Service Bulletin

No. : MZ07-040

Model: SR7001, SR8001

Subject: Software Update Information.

AFTER MODIFICATION

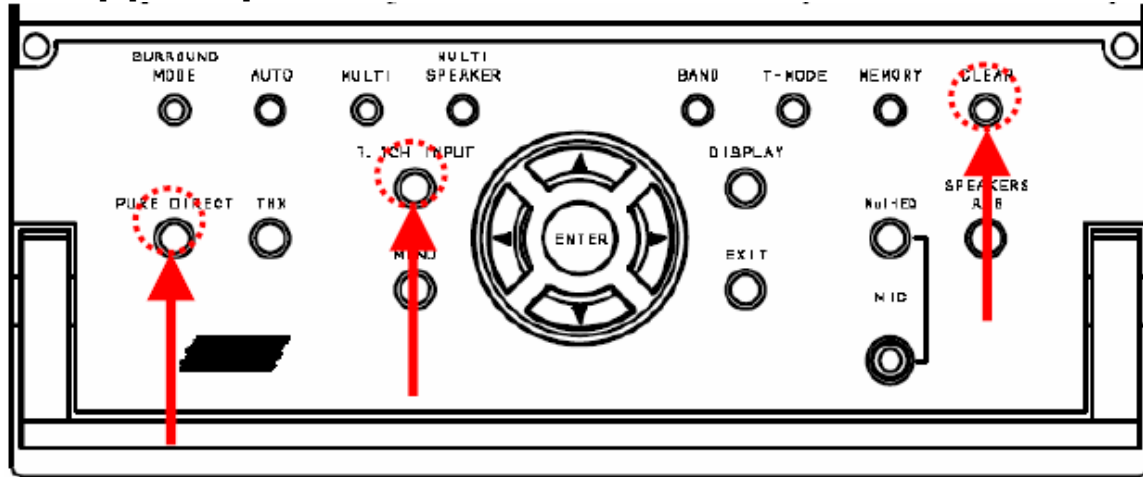
Symptom: Update the software in order to minimize component over dissipation if the power amp output transistors fail.

Solution: 1. Change the procedure for the protection operation that may be performed while the unit is in operation.

Originally, the unit was designed to go into STANDBY mode with the STANDBY LED flickering every 500m sec. upon detection of an abnormality; it would never be powered on by the standby switch or the remote control, so component over dissipation never occurred. However, if the unit was plugged in again, it could occur before the unit went into standby a few seconds later.

The unit has been modified never to be powered on by any means once it goes into standby with the standby led flickering every 125m sec., unless the specialized procedure (*1) described below is performed.

***1: If the unit cannot be powered on after being plugged in again (with the STANDBY LED flickering every 125m seconds), the power amp has failed. The unit still can be powered on again through the following method, but it can further damage the power amplifier. Please never let end-users perform this procedure.**

Can be powered on by “FACTORY KEY” = [PURE DIRECT]+[7.1 CH INPUT]+[CLEAR]
